30 May 2023

WOOD MIDDLE SCHOOL MODERNIZATION & NEW CONSTRUCTION

Design Meeting #6 – MEETING NOTES

- Conceptual Site plan copy below.

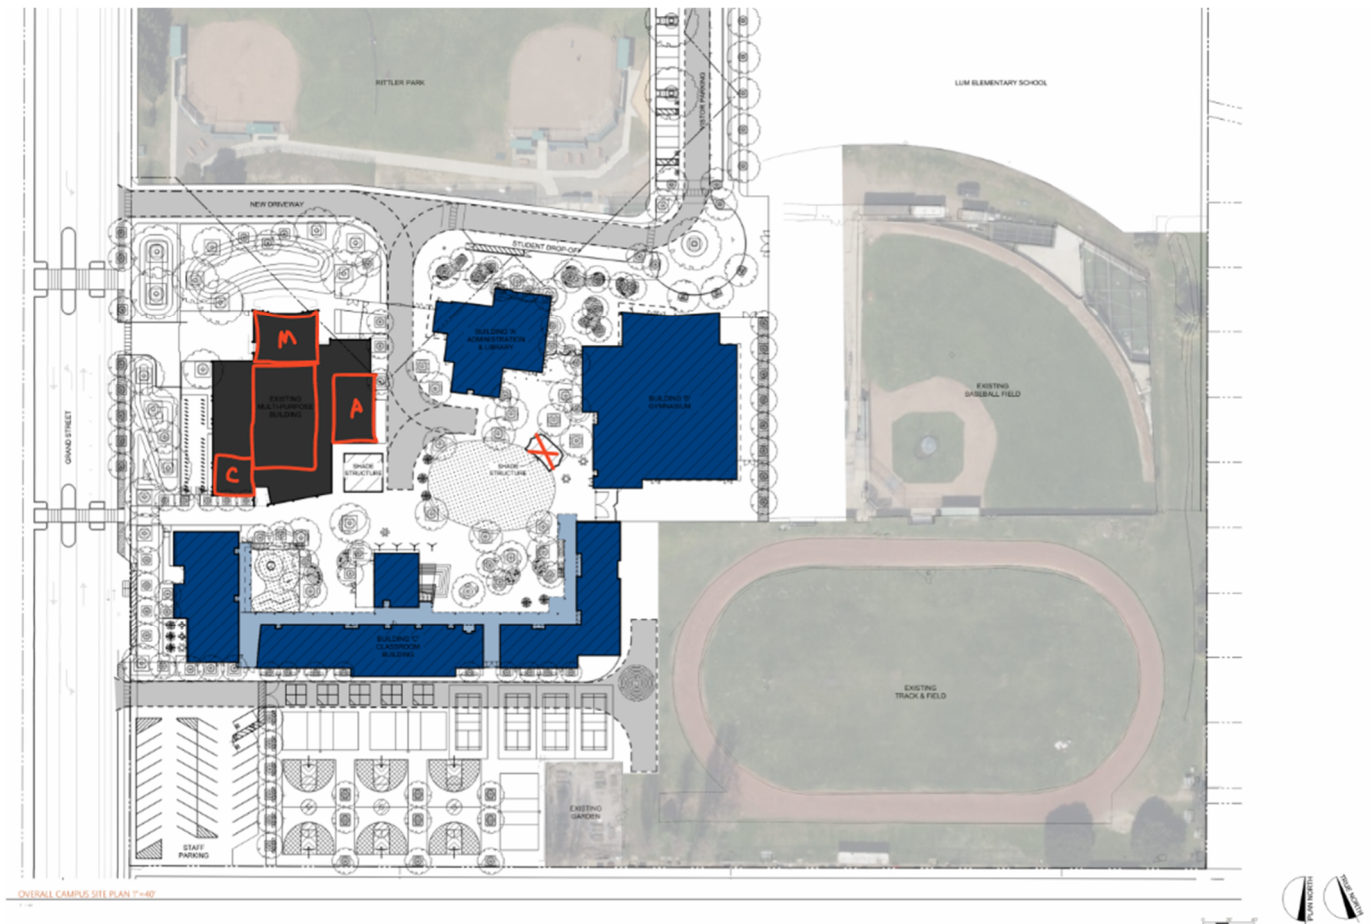
- Review and discussion of reducing and eliminating site plan features and building items will be discussed in an open and honest way so informed decisions may be made by attendees.
- The cost estimate of landscape design came in high, and the plan is to reduce \$3 million off the estimate.
- Eliminate fabric shade structure at quad. Keep shade structure by MPR building for outdoor lunch.

- Use asphalt paving instead of concrete paving in some areas of the quad.
 - Asphalt paving will have an absorbing non-textured coating that comes in colors that reduce heat gain.

- Robbie [RL] commented that Wood MS currently has asphalt paving so what is being provided is nothing different. Just need to go with more asphalt paving in lieu of concrete to help reduce cost.

- Mark [MQ] commented that there will not be a sea of asphalt paving as the school's focal point. Gathering spaces with less trees will still be provided.

- Robbie [RL] suggested doing concrete in the quad area in lieu of asphalt concrete as a bid alternate so if the bid comes in at a low cost, then concrete paving can possibly be provided.

- Provide regular asphalt paving in playground areas instead of colored coating. Eliminate sport coating.
- Lindsey [LS] suggests the possibility of connecting with local non-profit organizations for landscaping assistance, donations or fundraising by asking people to help purchase trees and plants.

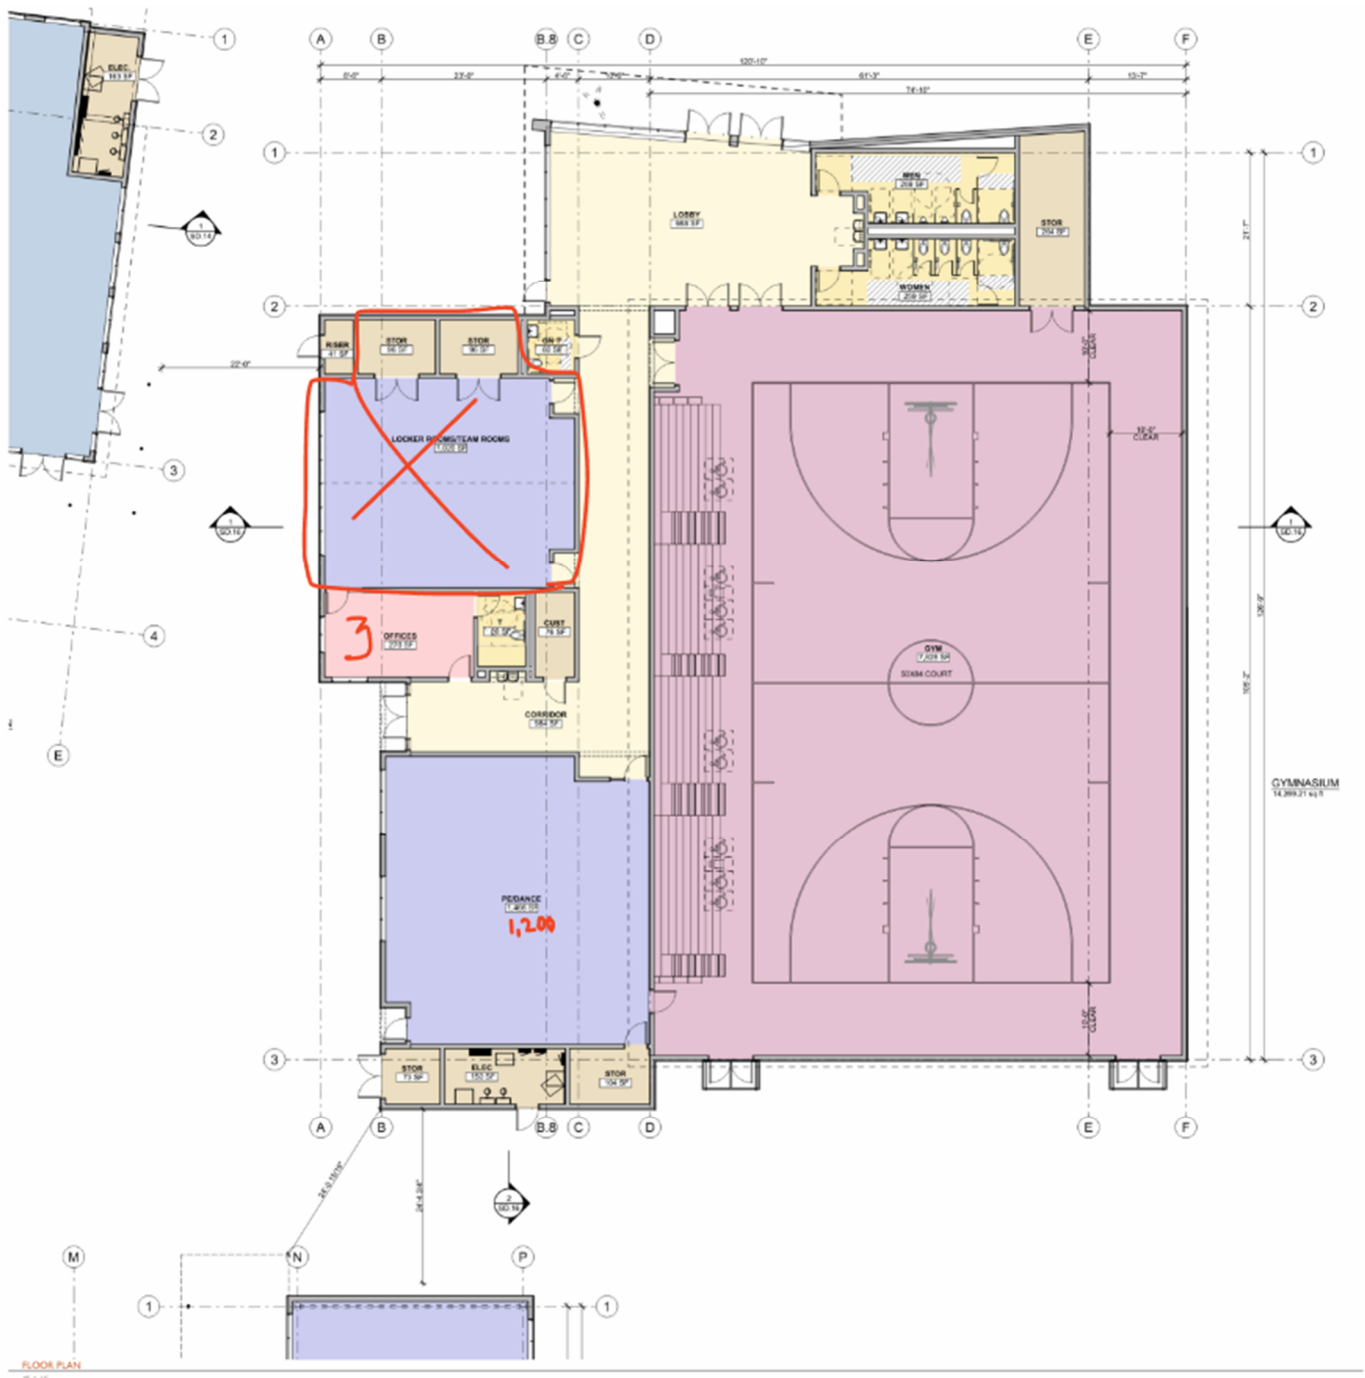
- Reduce the number of mental health office counts from 7 to 5. Provide 2 offices in the Admin Building and 3 offices near Intensive Needs classrooms in the 2-story Classroom Building.
- The building design will not change dramatically by deleting a couple of the offices.
- Monica [MB] commented that security and safety of admin staff from visitors is important. Like the service counter, wall, and door to separate visitors from the staff and admin workspace.
